[Docket No. 99-NM-22-AD; Amendment 39-11640; AD 2000-05-30]

Airworthiness Directives; Boeing Model 747 Series Airplanes

ACTION: Final rule.

FIGURE 1

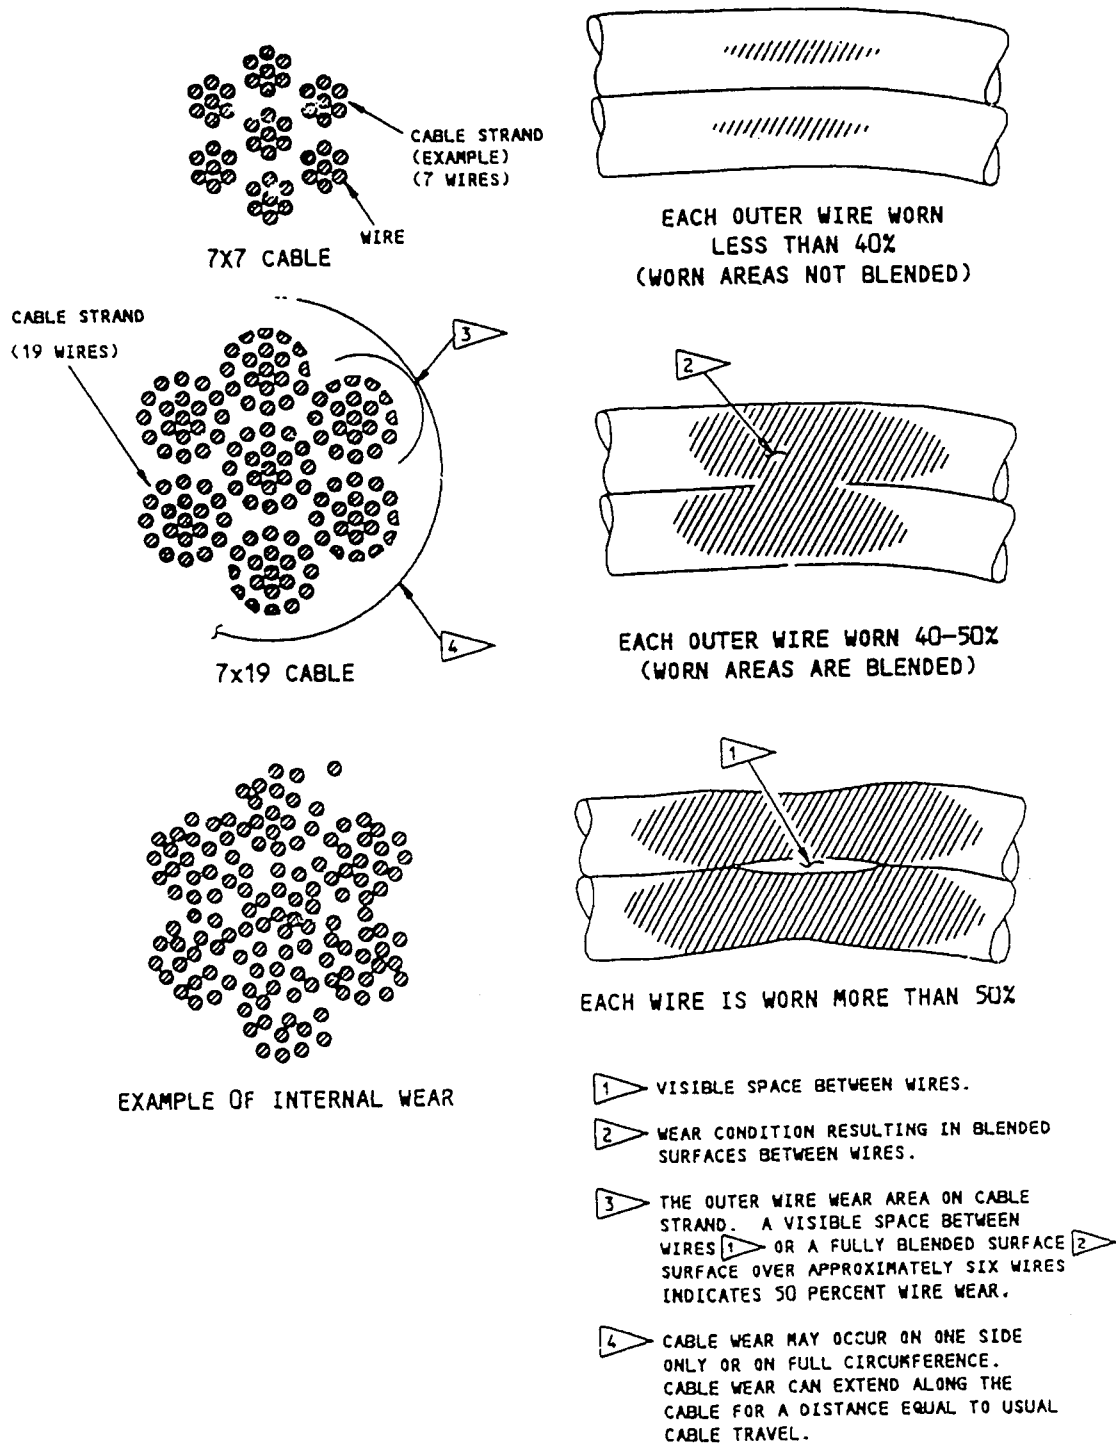
The FAA has revised Figure 1 of Appendix 1 in the final rule to correct the percentage of wear of each outer wire of the thrust control cables as illustrated. The correct percentage (40%) was specified in Appendix 1, Paragraph 2.B.(1) of the proposal. Figure 1 of Appendix 1 in the proposal illustrated, "Each outer wire worn less than 50%." Figure 1 of Appendix 1 in the final rule illustrates "Each outer wire worn less than 40%."

(1) One cable strand had worn wires where one wire cross section is decreased by more than 40 percent (see Figure 1),
